DOR Patch Cable Connector

Patch Panel

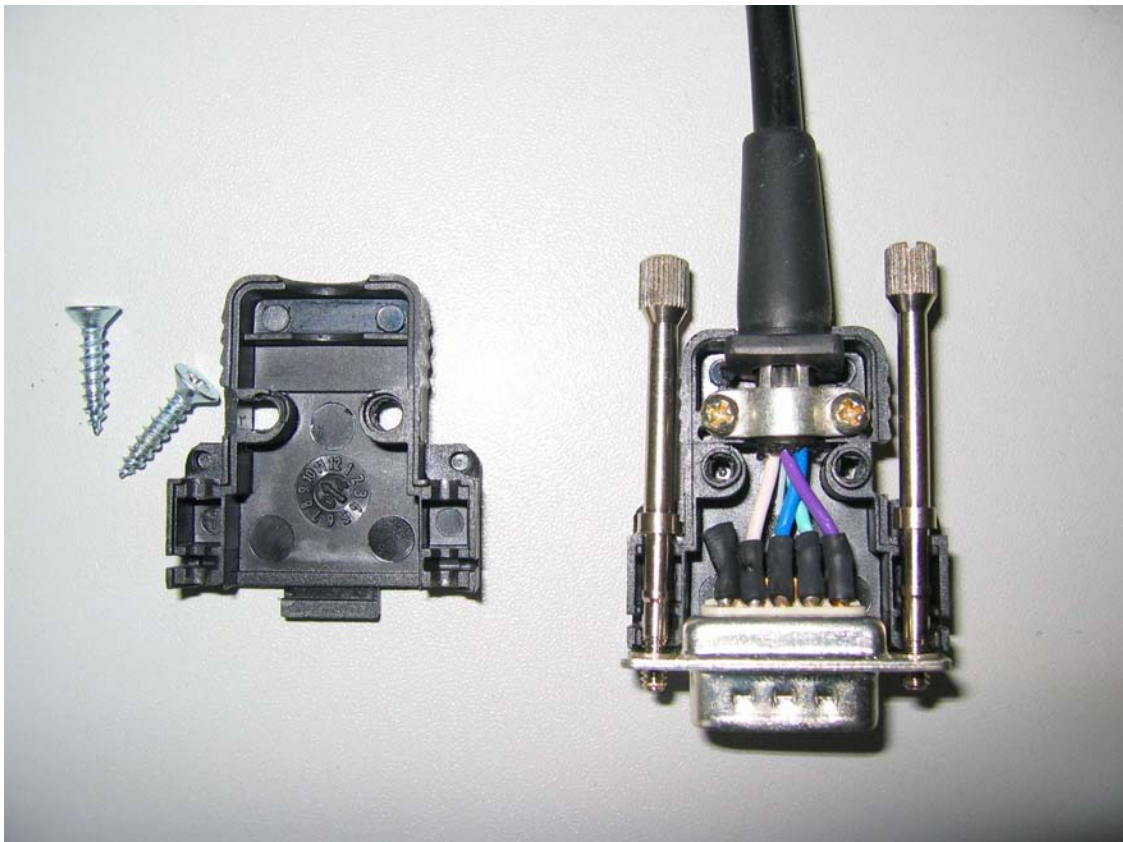
- fixing bolts should be LONGER than the shell to have an easier access
- connector shells should have TWO bolts to guaranty a solid connection and to avoid a bended single bolt by force on the cable
- the cable should be fixed to the connector shell
- the shield can get connected to pin 1 or outside to a GND-rail (foreseen at the DOM hub already ?)
- see below an example (150 ohm AMANDA cable), the shell can accomodate thicker cables by leaving out the rubber tube

- cylindric connectors to be fixed by rotating a part of the shell can result in a loss of the connectivity in case the (not properly fixed) cable get accidentally rotated as well
- the above described effect can result in shortcuts (96V !!!)
- a patch panel consisting out of DSUB connectors would avoid this and make the patch cable design (1:1, male to female) easier
